CITY OF DUBLIN, FRANKLIN COUNTY, OHIO  
PRELIMINARY DEVELOPMENT PLAN  
FOR  
BRIGHT ROAD RESERVE

TITLE SHEET/VICINITY MAP/REGIONAL CONTEXT MAP

## 16. Concept Review Plans (for reference)

The following information is a summary from the Concept Review phase of this project's process, dated 5/15/24 and Planning & Zoning Commission Hearing dated 6/20/24. In addition to the narrative, plans and other supporting graphics submitted above for review, we are herein summarizing portions, in direct quotation and/or paraphrased summary of the Meeting Minutes prepared by Staff, of Commission comments, Public comments, Commission questions and discussions among Commission Members and with the Applicant. Additionally, Applicant is providing brief "responses" to each of these items, where appropriate, demonstrating understanding and consideration of all through written descriptions supported by the narratives, standards and descriptions submitted as a part of this Preliminary Development Plan and Preliminary Plat. This summary information is provided as a convenience to the Staff, Commission and the public as they consider the merits of this proposed development.

STREET SECTIONS  
SCALE: 1/8" = 1'-0"

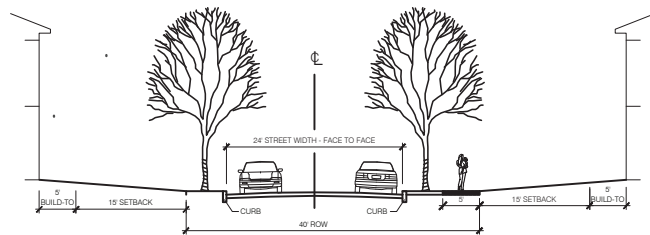
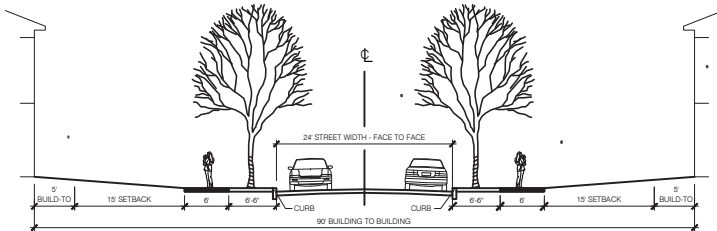
Developer-Proposed Street Section

City-Proposed Street Section
